Uranerz Energy Corporation Nichols Ranch ISR Project

Response to the NRC Request for Additional Information

Pre-Operation License Condition 12.8 Supplemental Information March 11, 2014

NICHOLS RANCH ISR PROJECT
DRAFT FIGURE 2-25
NICHOLS RANCH UNIT
RADON/GAMMA/AIR
PARTICULATE MONITORING LOCATIONS

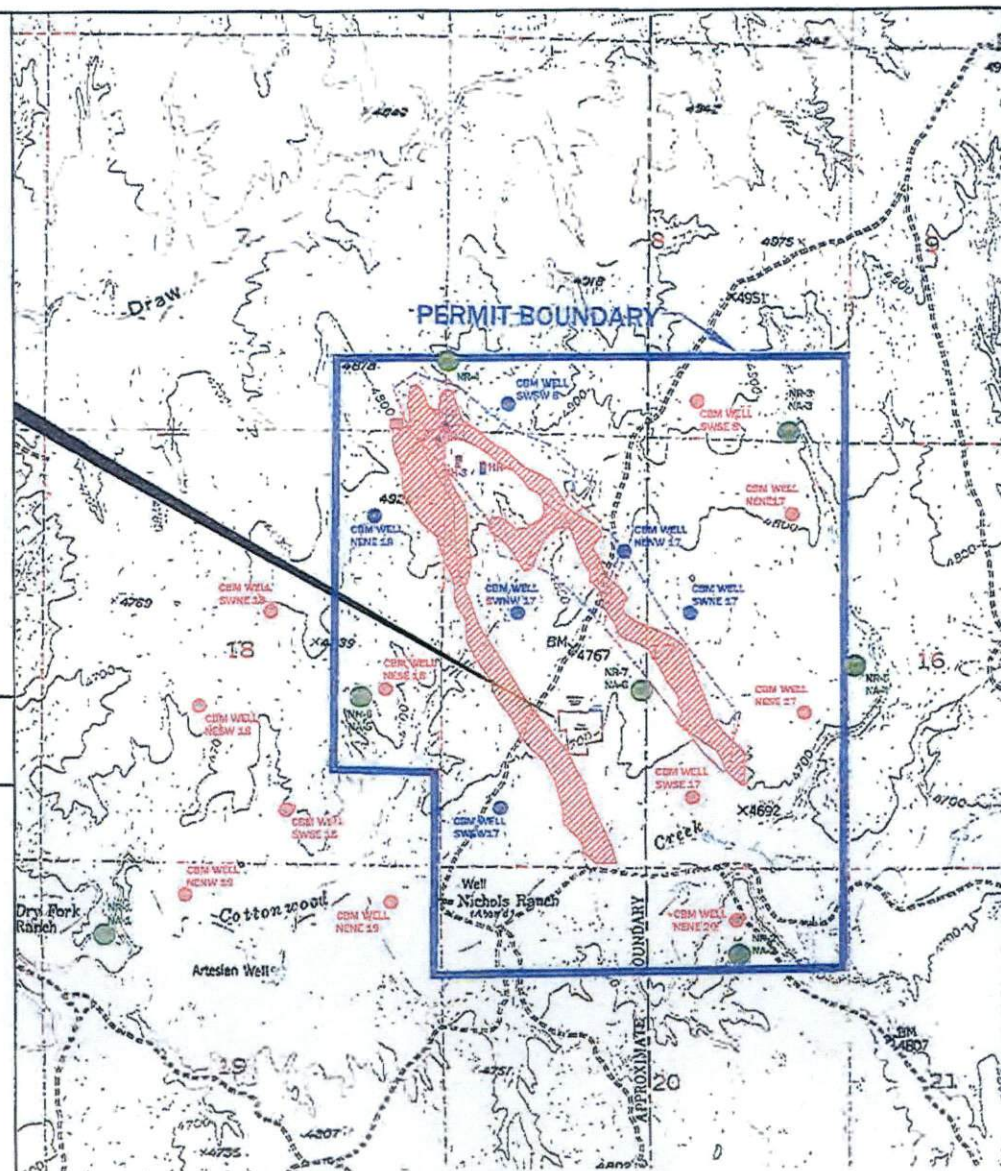
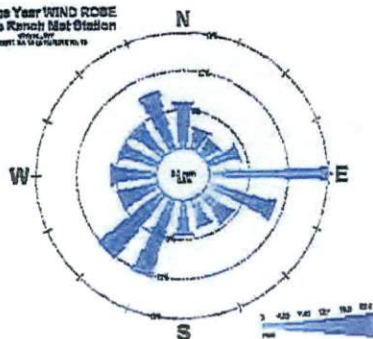
Attachment 2 contains draft Figure 2-25. The figure depicts the location of the environmental air samples, RADTRAK locations, and gamma dosimeters in the Nichols Ranch Unit license area.

Figure 1 Regions of Similar Projected Exposure (Isodose Curves) at the Nichols Ranch and Hank Project Sites

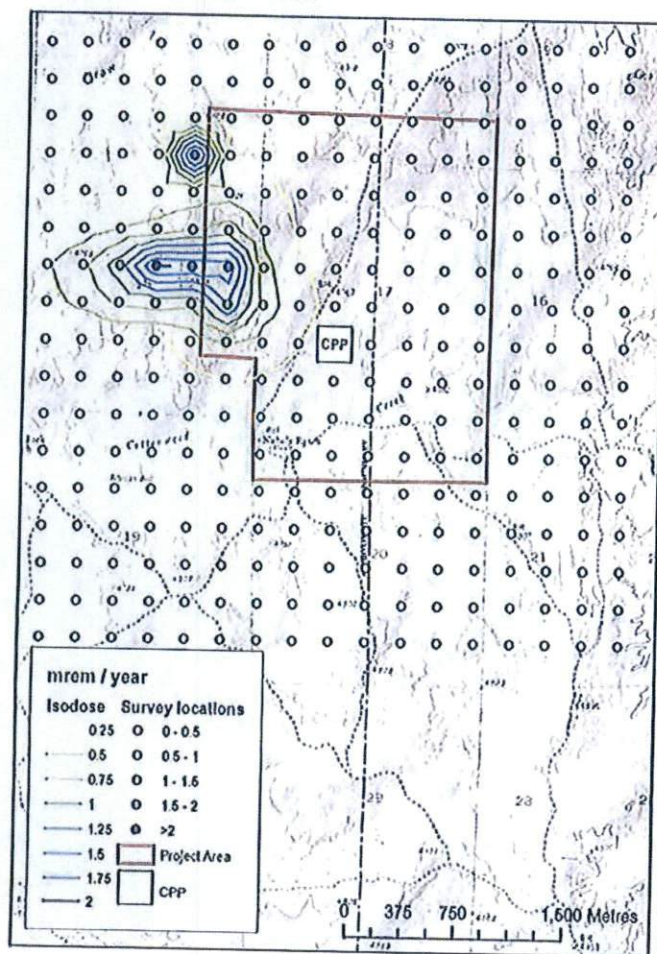
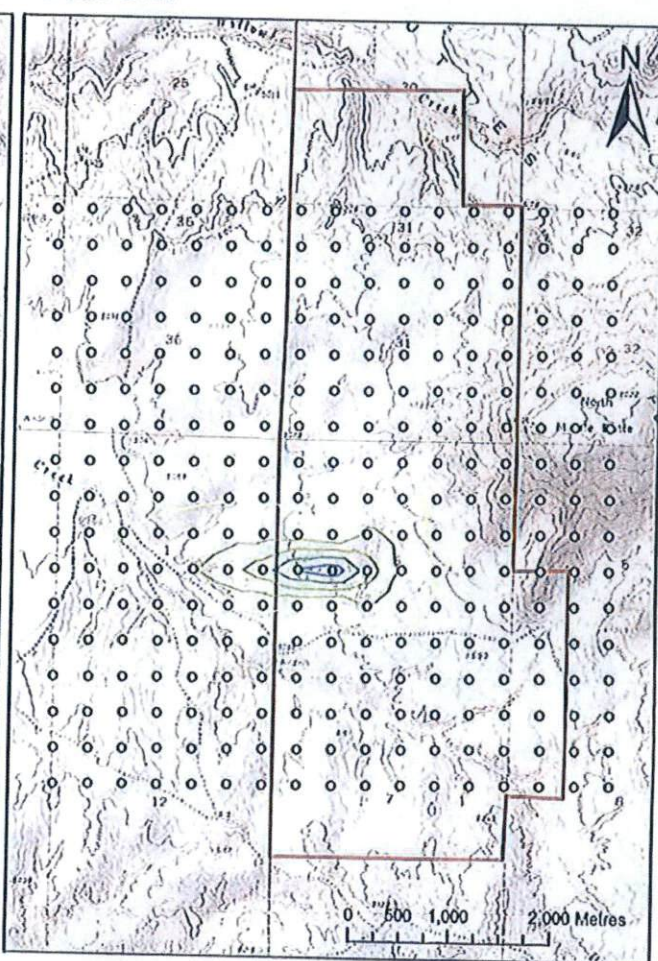
The MILDOS model was used to calculate doses to the generic worker at 576 locations around the Nichols and Hank units at the Nichols Ranch Project area. MILDOS modeling shows that the highest doses to the generic worker are found in time steps 5 and 6, i.e., during the time period when both the Nichols unit restoration and the Hank unit production is occurring (time step 5) and during both units' restoration phases (time step 6). This is expected as the restoration source term for the Nichols unit was the highest and the production source term and restoration source term for the Hank unit are quite similar. **Using the predicted exposures doses were calculated for individual receptors.** The map depicted in Figure 1 presents the dose estimate results overlaid on the site map, with regions of similar dose connected to produce isodose curves over the property. The isodose lines on these maps represent regions of similar dose. No doses below 0.5 mrem/yr were included as survey locations on this map. A table of all doses from the time step of highest predicted exposures (step 5) is included as Attachment 1 at the end of this document.

The maximum dose modeled by this analysis at the Nichols Ranch Project site was located at 1.25 km west and 0.5 km north of the center of operations at the Nichols unit. The maximum dose to a 40-hour a week, generic worker at this location as a result of radon effluents* from the facility was estimated to be 2.02 mrem/yr. The dose to the generic worker at this location over all time steps modeled for construction, production, and restoration phases at the Project is shown in Figure 2. The dose projected to the generic worker at this location is greater than the dose predicted for an individual with estimated occupancy times.

Figure 2 Dose to the Maximally Exposed Generic Worker

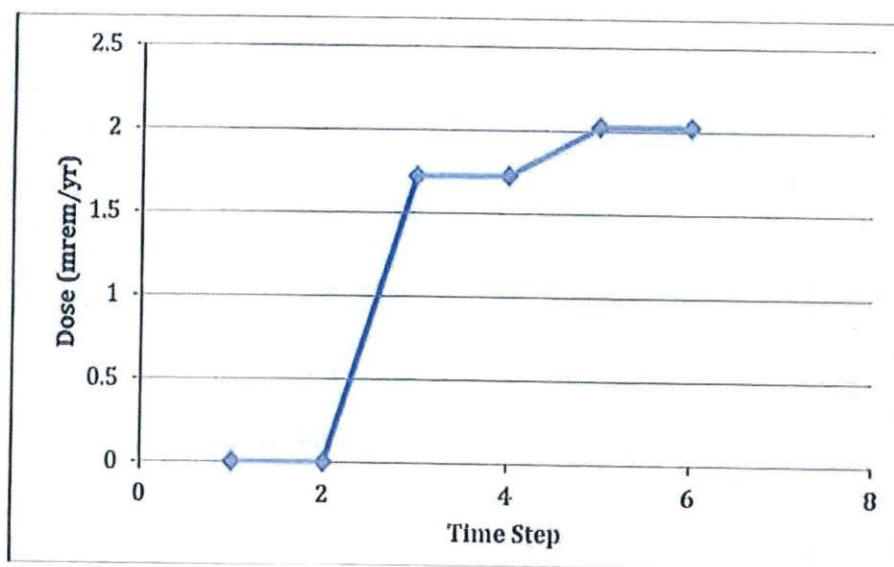
The dose to the maximally exposed generic worker is slightly more than twice the dose to the maximally exposed resident at the Pfister Ranch (identified in the original Nichols Ranch Technical Report, Table 7-8), with a dose estimate of 0.9 mrem/yr. This result is expected, as the Pfister Ranch is located approximately 10 km from the center of the Nichols Unit operations. However, this dose is lower than the largest public dose (5 mrem/yr) previously predicted at the east-central permit boundary of the Hank Unit from the previous analysis (Section 7.3.1.2.8.1 of the Technical Report), which assumed this receptor to be a full time, resident farmer.

NICHOLS RANCH ISR PROJECT
DRAFT FIGURE ???
NICHOLS RANCH UNIT
RESTRICTED/CONTROLLED/UNRESTRICTED AREAS

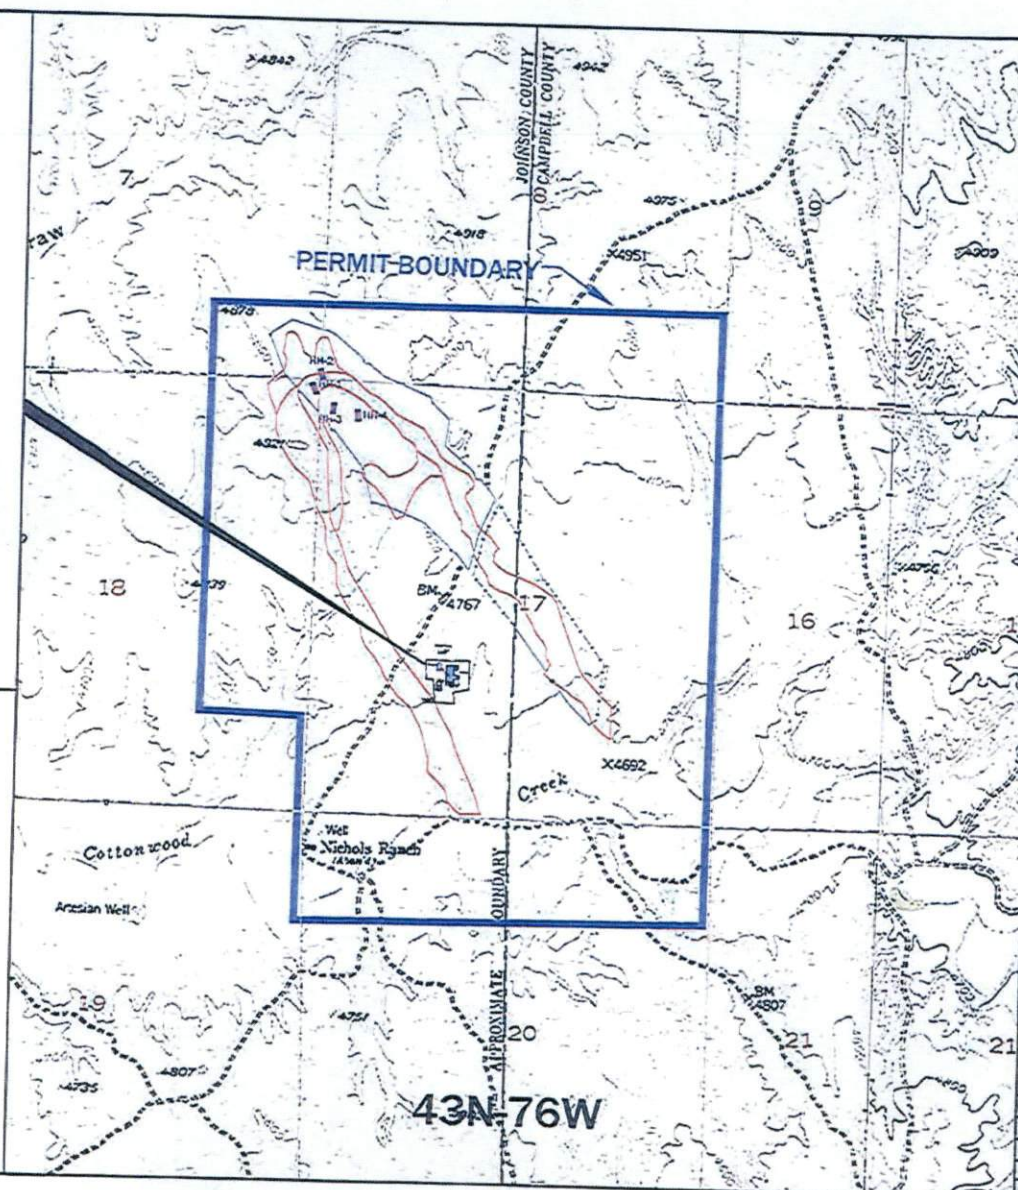
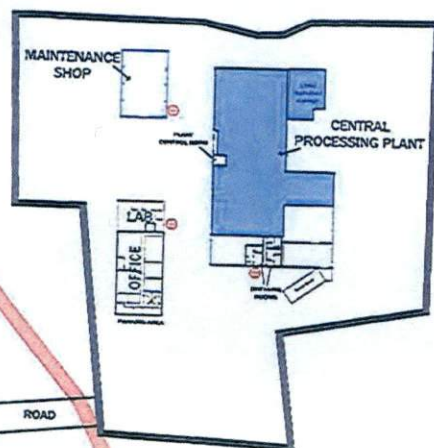
In the attached plate “Restricted, Controlled, Unrestricted Areas” (Attachment 5), Uranerz depicts areas that will be considered restricted, controlled, and unrestricted. **Controlled areas reside within fenced boundaries, such as Production Areas, with access points conspicuously posted. Controlled areas also include buildings with locks which limit access, such as header houses.** Currently, the only restricted area is within the CPP where all access doors are locked. Uranerz has the authority through surface use agreements with the landowner and in Wyoming Department of Environmental Quality – Land Quality Division Permit to Mine No. 778 to remove unauthorized individuals present in areas designated as controlled or restricted. These restrictions apply to Nichols Ranch only since construction has not commenced on Hank Unit. With these designated controlled and restricted areas any other area is considered to be an unrestricted use area. The boundaries for unrestricted areas are at the fence lines common with the controlled areas.
